Docket No. 50-213  
B14881

Attachment B  
Haddam Neck Plant  
Walkdown Summary Report  
Replacement Pages

June 1994

NUSCO CONNECTICUT YANKEE		GIP Rev 2, Corrected, 2/14/92 Sheet 1 of 1
ID : CY-MCR		
Description : CY - MAIN CONTROL ROOM		
Building : CB	Floor El. : 59.50	Room, Row/Col : MAIN CONTROL ROOM

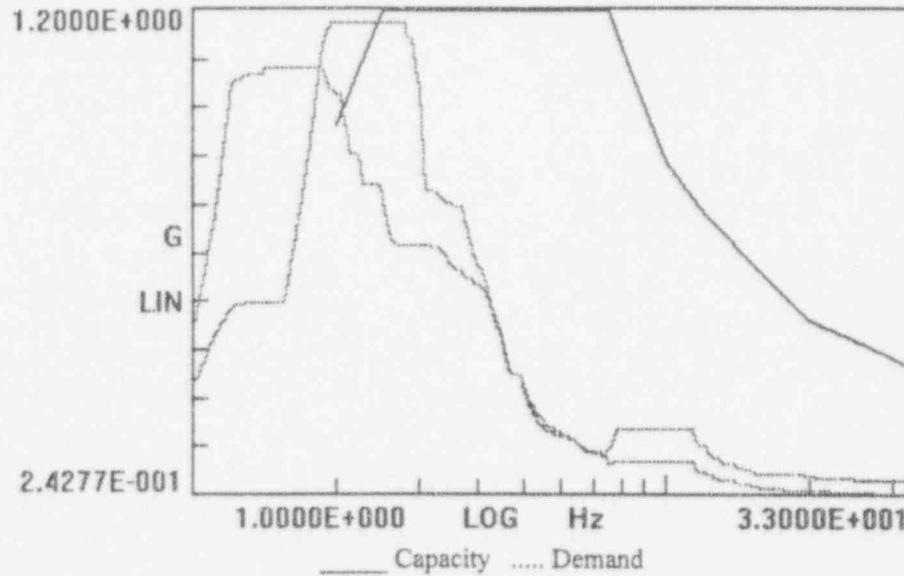
Capacity Basis - Component reference spectra envelops conservative floor response spectra for frequency greater than 2 Hz, component frequency is significantly higher than 2 Hz therefore the non enveloping region is inconsequential.
